RESPONSE LETTER

Manuscript Number: egusphere-2026-1378

Title: Managed Aquifer Recharge in Confined Multi-Layer Aquifers: A Scalable Framework for Drought Resilience in Central Europe

Response to the Reviewer #3:

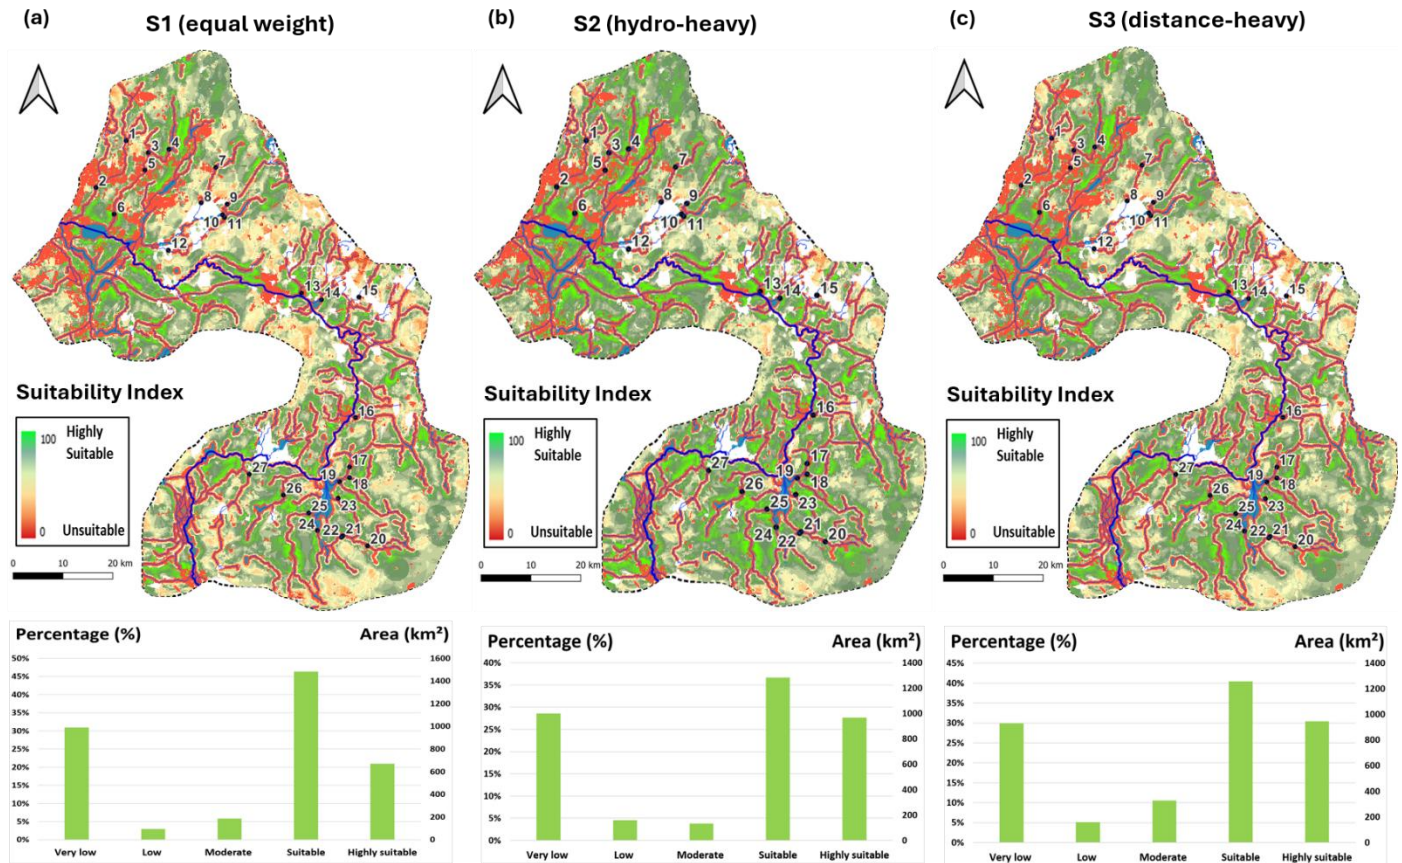
2-The suitability assessment represents one of the core outputs of the study, yet no uncertainty analysis appears to be conducted.

We agree that addressing uncertainty is critical. We have added a paragraph in Section 4.3 detailing our uncertainty approach. We used the sensitivity analysis on criterion weighting (Table S3) to demonstrate the robustness of the suitability map across different scenarios. Additionally, we clarified that the strict application of absolute constraint masks (e.g., Well Protection Zones) significantly mitigates spatial uncertainty and prevents false-positive site selections.

Sensitivity Analysis Results: We tested three weighting scenarios (Table 2). Results demonstrate high robustness (Fig. 6; Table 3). The "Very Low" suitability class remained stable at ~29% across all scenarios (variation <0.3%), indicating physical constraints consistently define unsuitable areas. The "Suitable" class showed moderate variation (36.7-43.3%; $\Delta = 6.6\%$), while "Highly Suitable" areas varied between 17.2% (S3) and 27.7% (S2) ($\Delta = 10.5\%$).

Despite percentage variations, the spatial distribution of high-suitability zones remained geographically consistent across all scenarios (Fig. 6a-c), confirming that site suitability is primarily controlled by underlying physical characteristics rather than subjective weight assignment (Hani et al., 2023; Vandala and Mahed, 2025).
